REPORT OF FINDINGS  
OF  
INDEPENDENT REVIEW OF  
KEY TECHNICAL, INTERFACE AND  
CONSTRUCTION CONCERNS

NINE MILE POINT NUCLEAR STATION — UNIT 2  
NIAGARA MOHAWK POWER CORPORATION

STONE & WEBSTER ENGINEERING CORPORATION  
NEW YORK OFFICE

May 13, 1983

ATTACHMENT P.D. #016

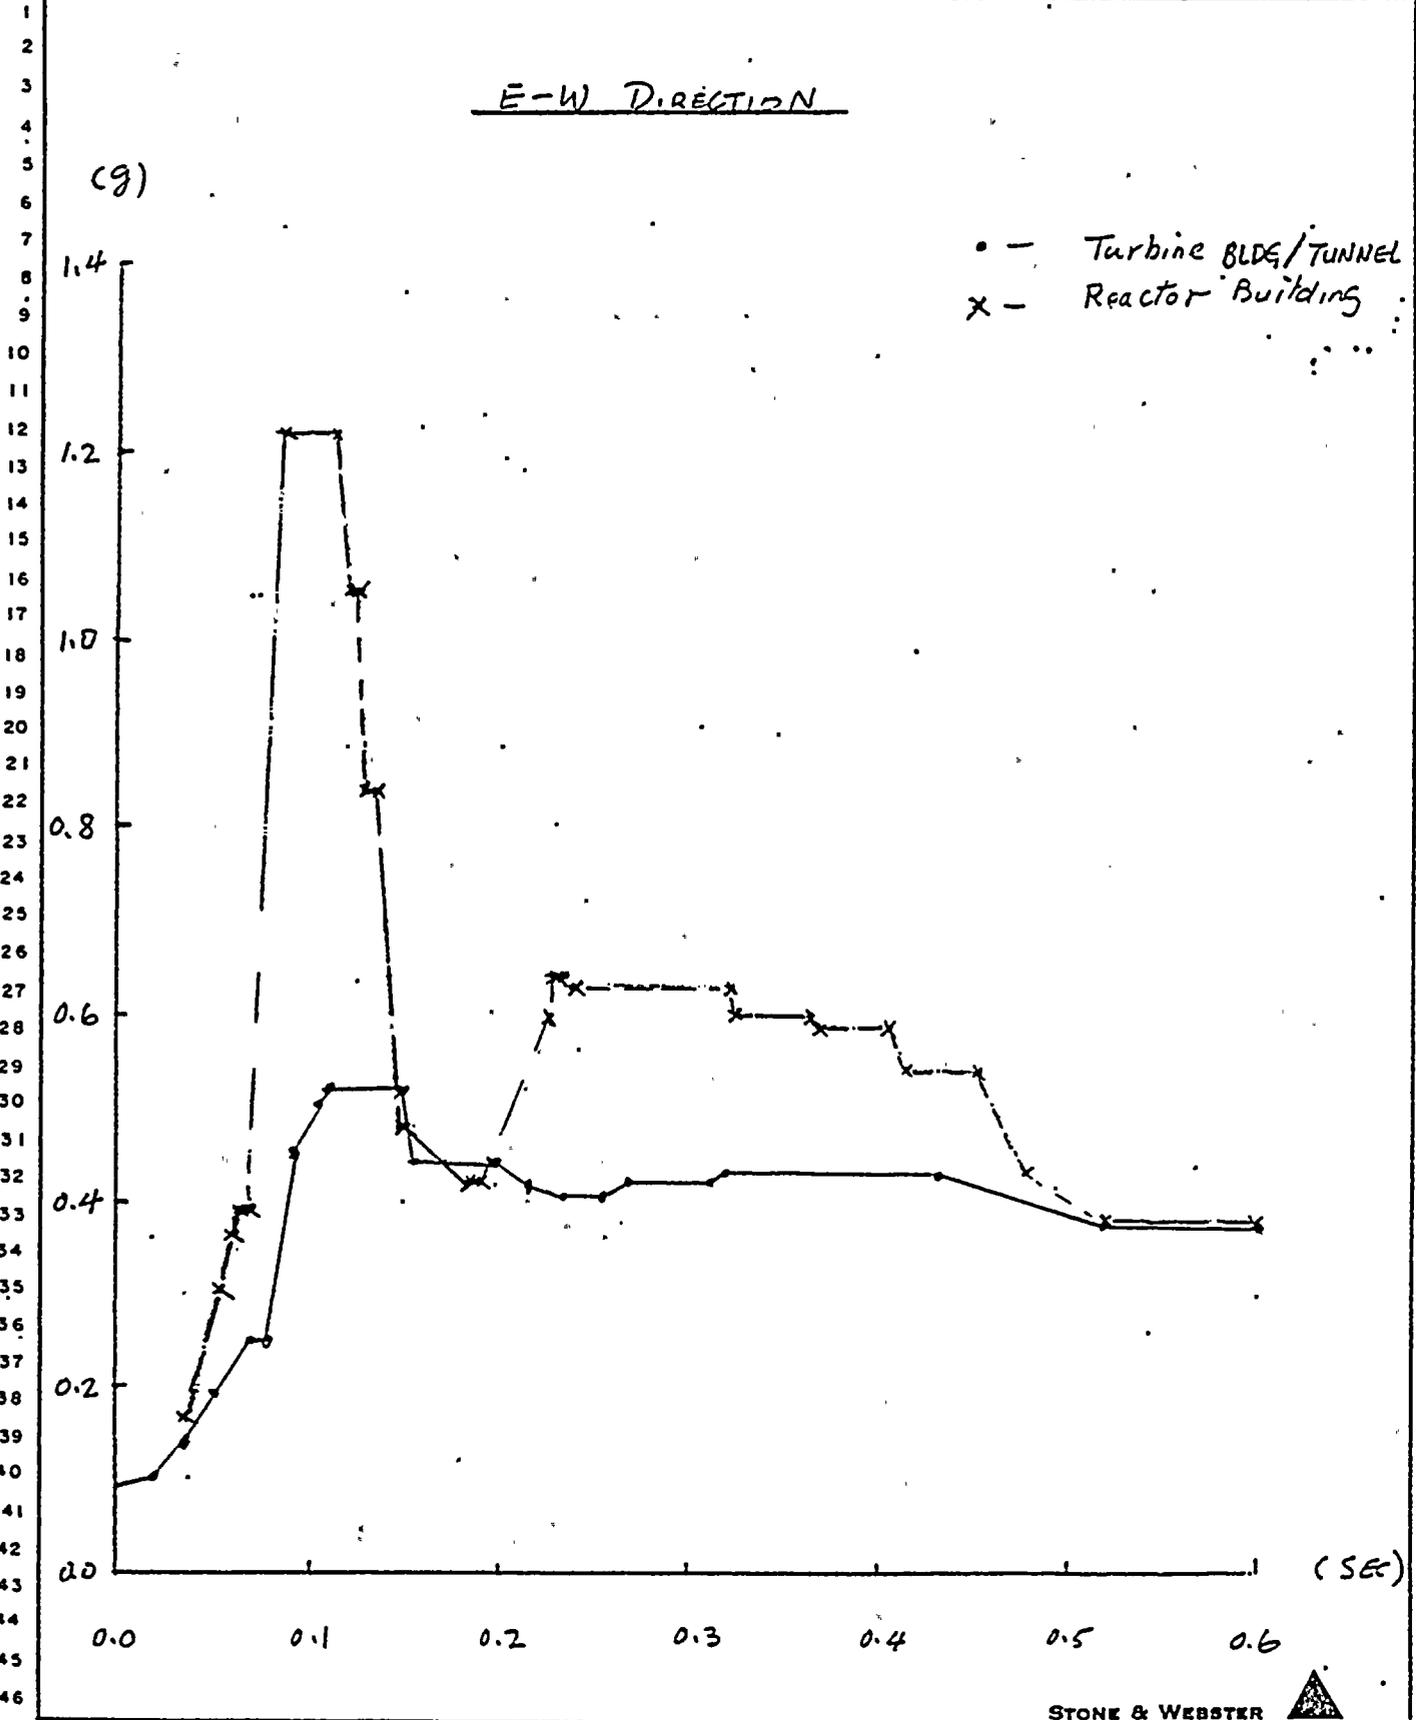
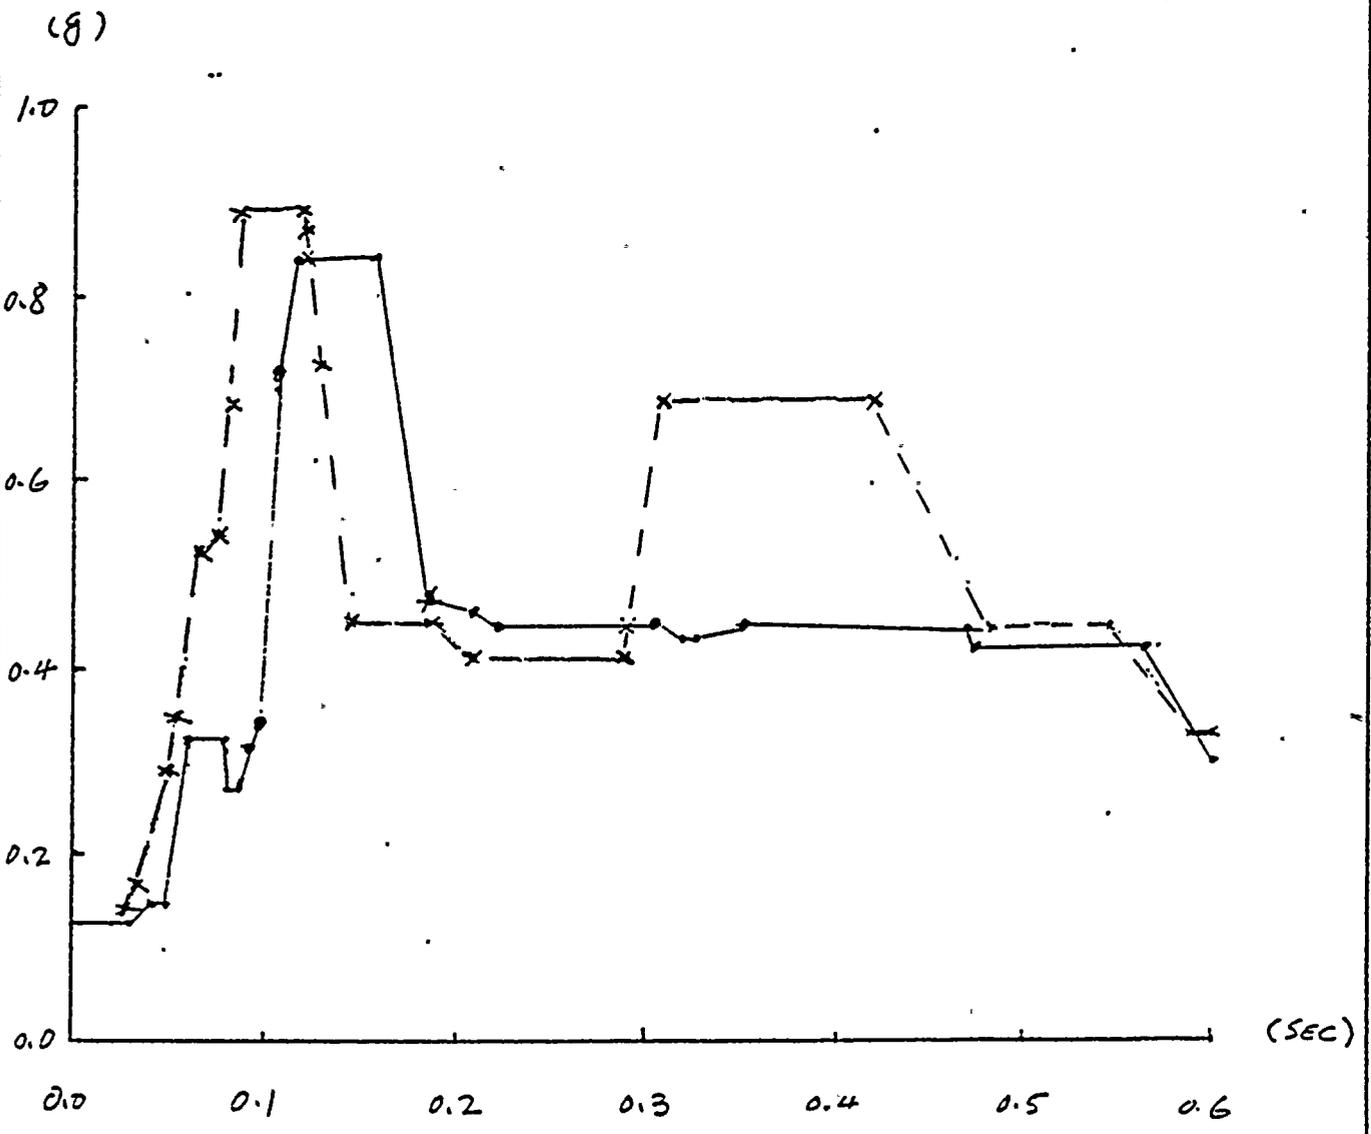
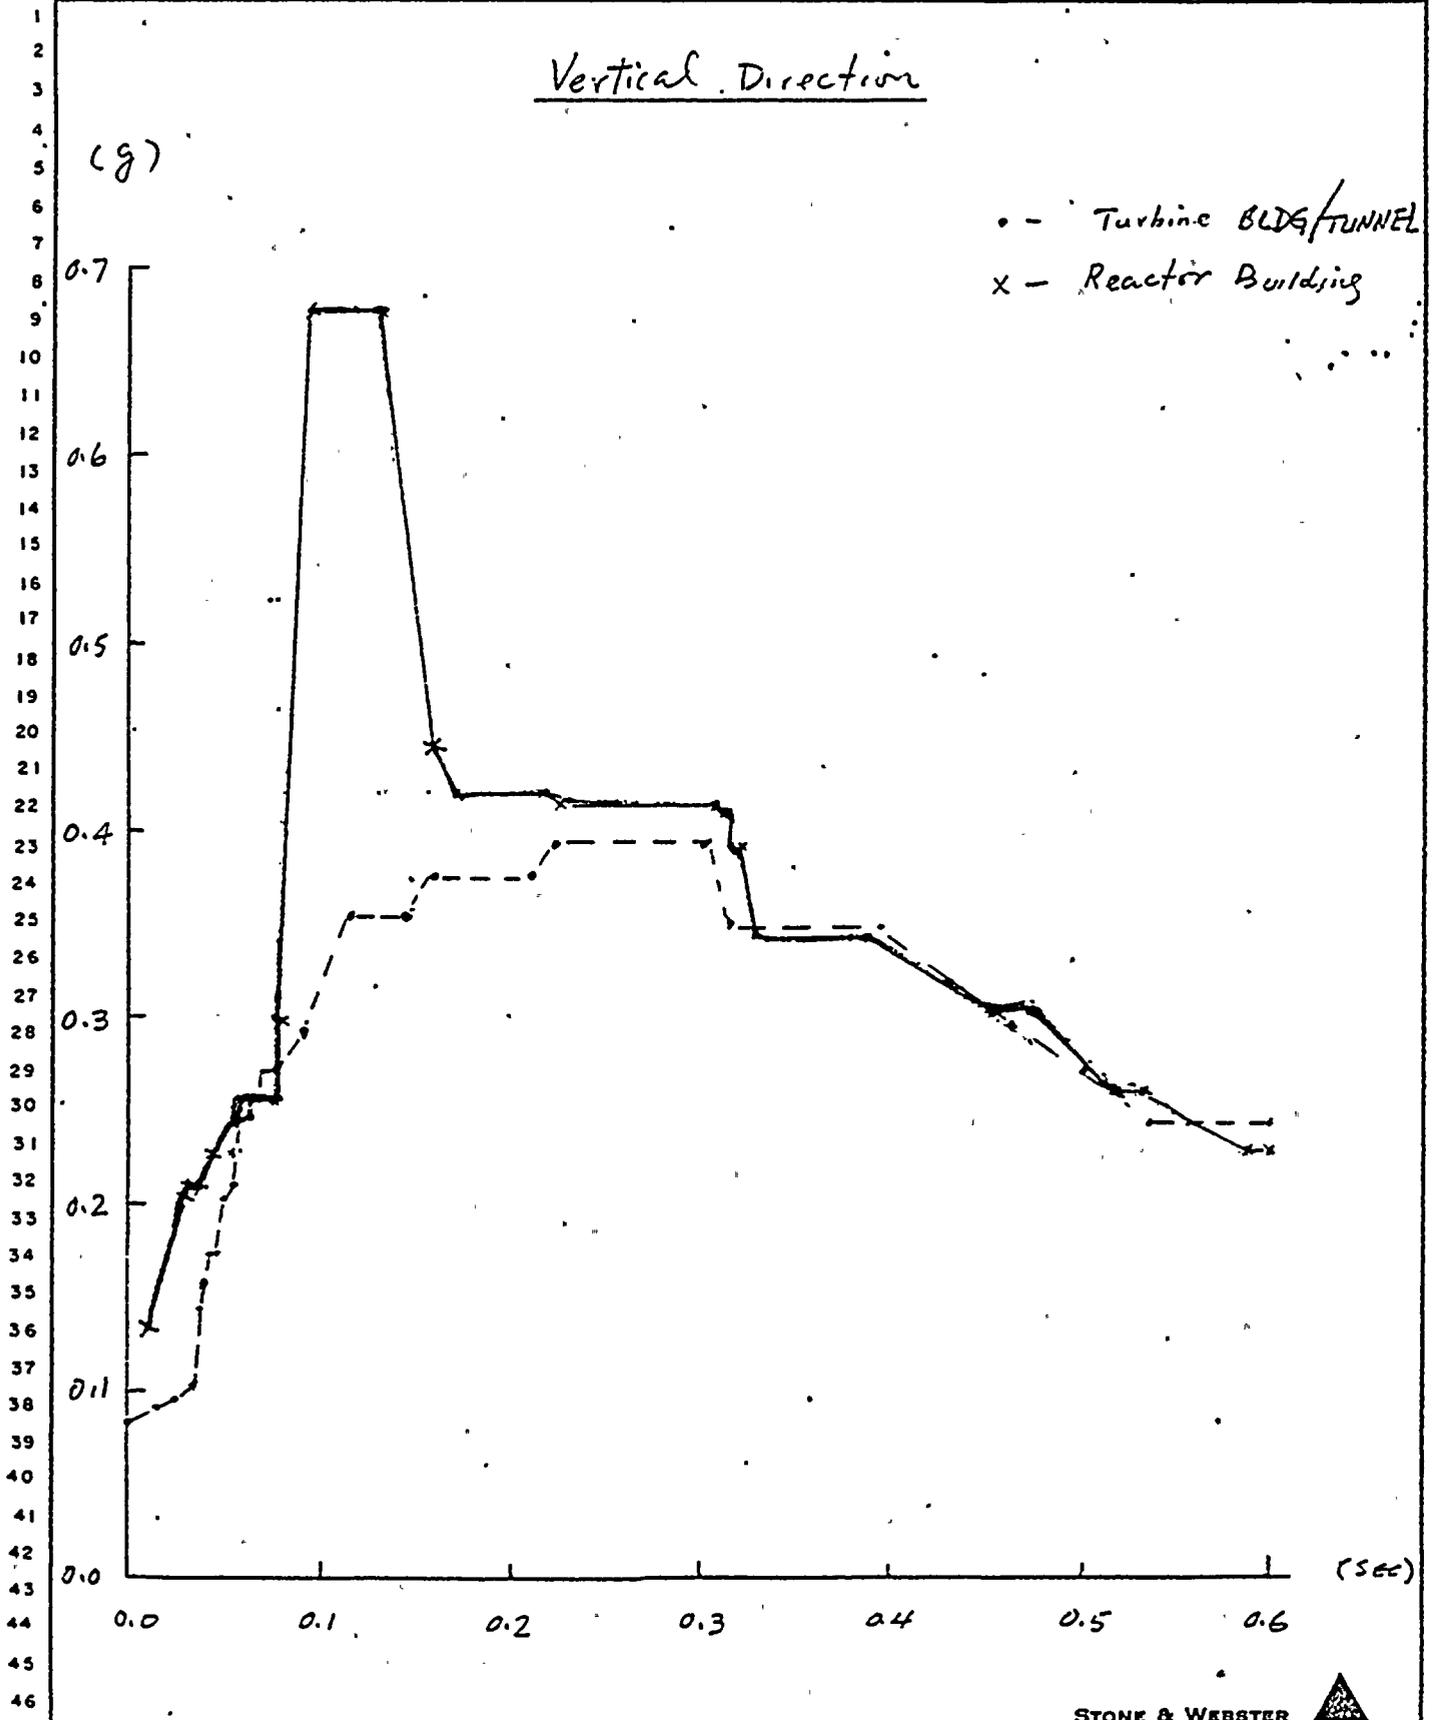
N-S DIRECTION
